NUCLEAR REACTOR LABORATORY
AN INTERDEPARTMENTAL CENTER OF
MASSACHUSETTS INSTITUTE OF TECHNOLOGY

Subject: Revision to MITR Technical Specifications #7.1 / Reply to Close Out
Open Item #50-20/2001-202-01

7. ADMINISTRATIVE CONTROLS

Fig. 7.1-1 Management Organization

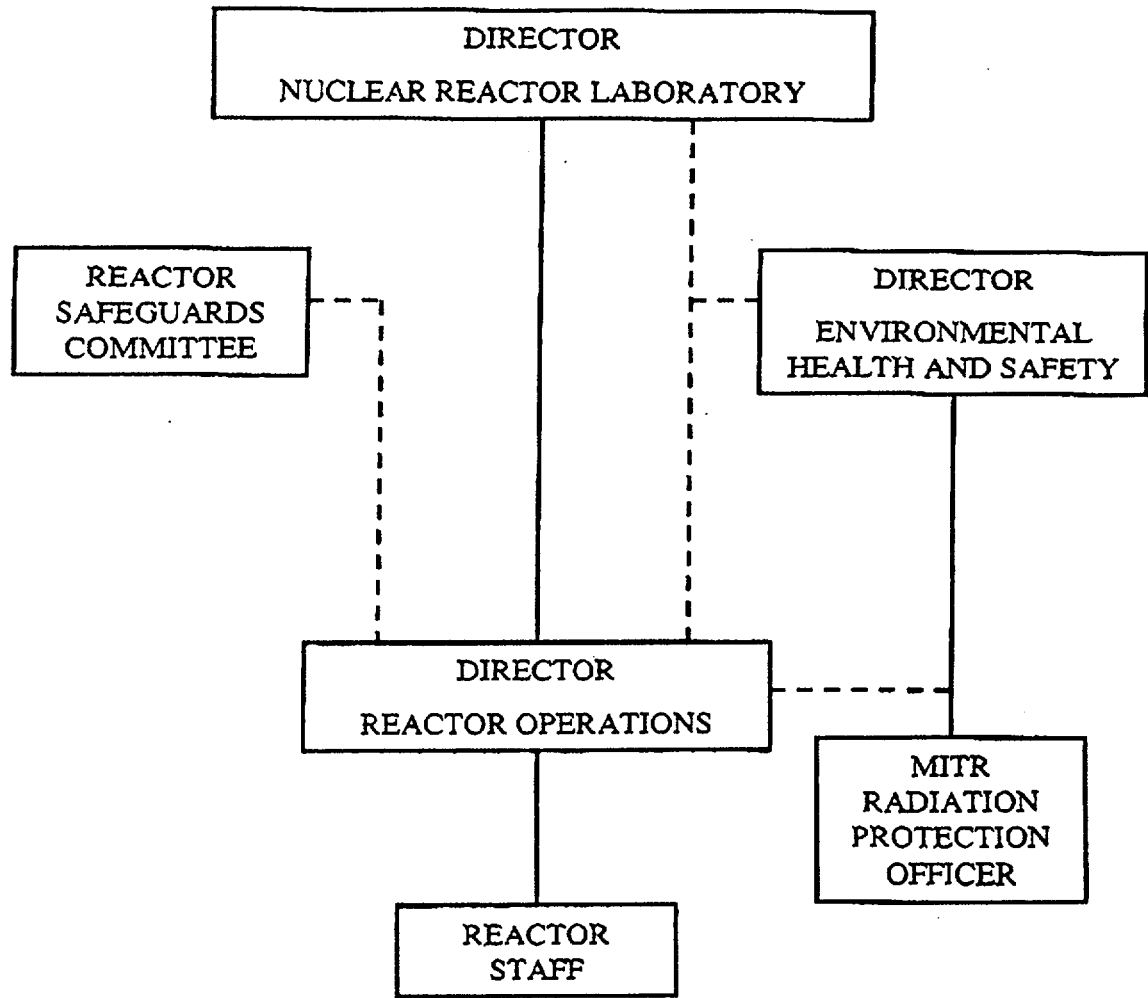
Enclosed is a revision to Massachusetts Institute of Technology Research Reactor
Technical Specification #7.1 which reflects changes in the administrative structure at MIT.
Please note that submission of this item should close out open item #50-20/2001-202-01
from NRC Inspection Report #50-20/2001-202 dated August 20, 2001.

7.1.2 In all matters pertaining to safe operation of the MIT Reactor (MITR) and to these Technical Specifications, the Director of Reactor Operations shall report to and be directly responsible to the Director of the Nuclear Reactor Laboratory. The management organization is shown in Figure 7.1-1.
